# NOPOWER, $V_{On\_PD}$ , and $V_{Off\_PD}$ v111

This comment addresses r01-450, 449, 347, 451, 348, 349, 452, 227, 314, 353, and 238.

Figure 145–26—Single-signature PD state diagram (continued)

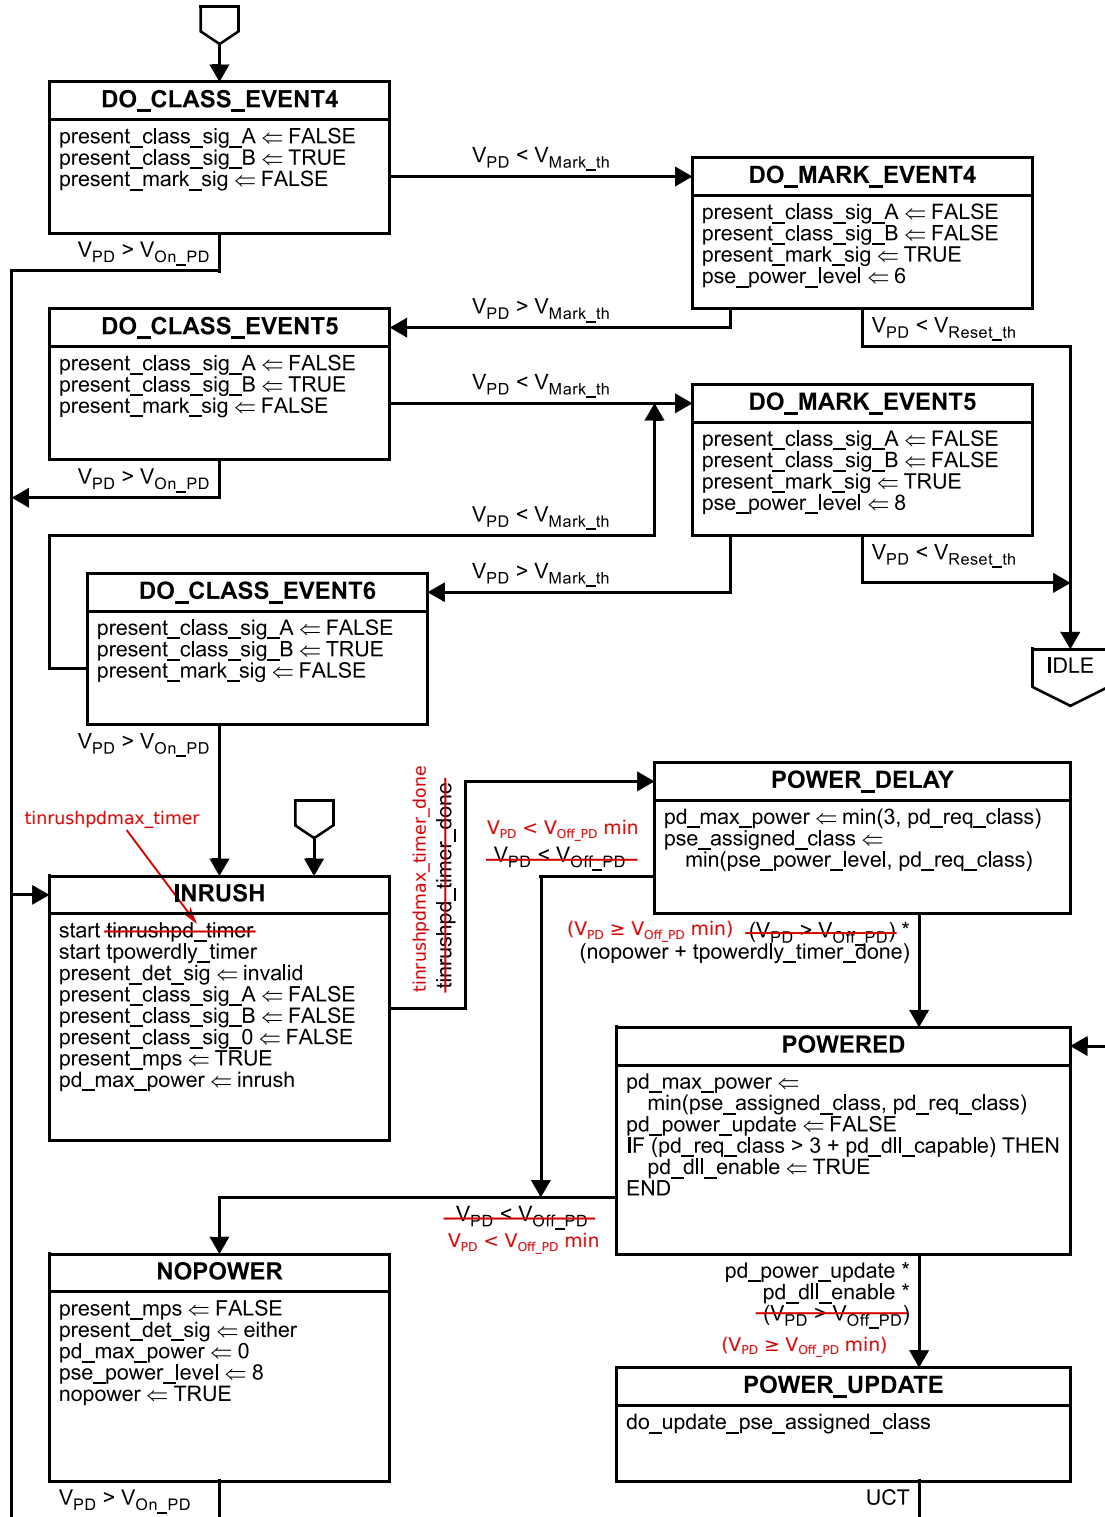
- the PD state diagram is forced to spend precisely 50 msin INRUSH (the state, not the condition).
- the entry logic into NOPOWER is changed to be  $V_{PD} < V_{Off\_PD}$  min.
- Add requirement that states a PD can't turn off due to compliant peak power draw or transients.

Change Figure 145–26 as follows:

Figure 145–28—Dual-signature PD state diagram (continued)

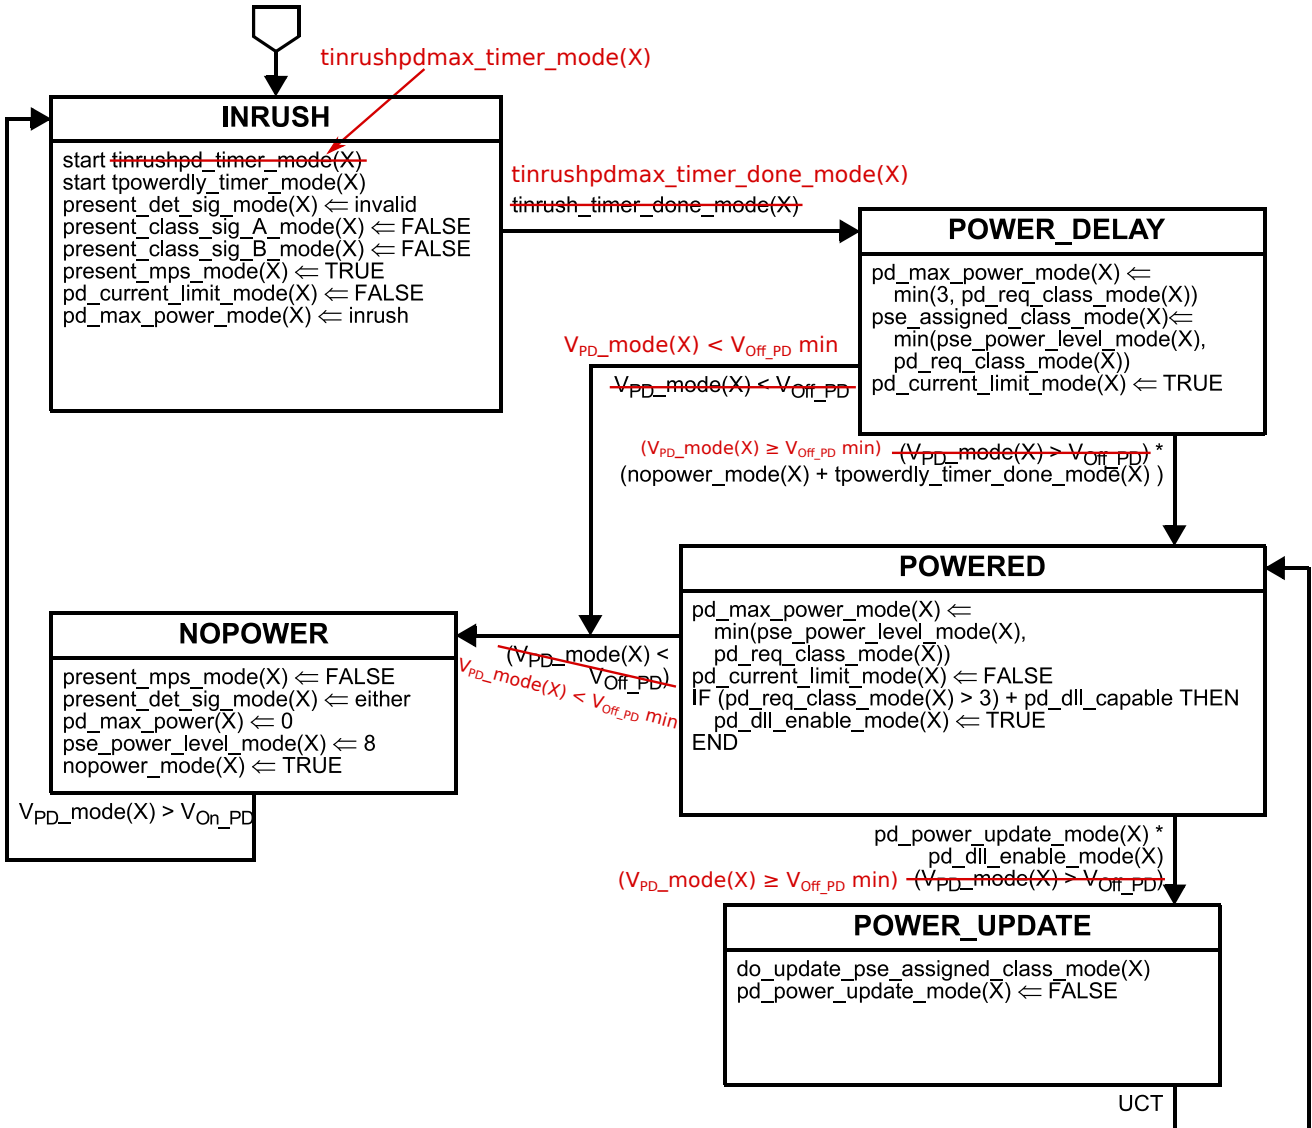
Change Figure 145–26 as follows:
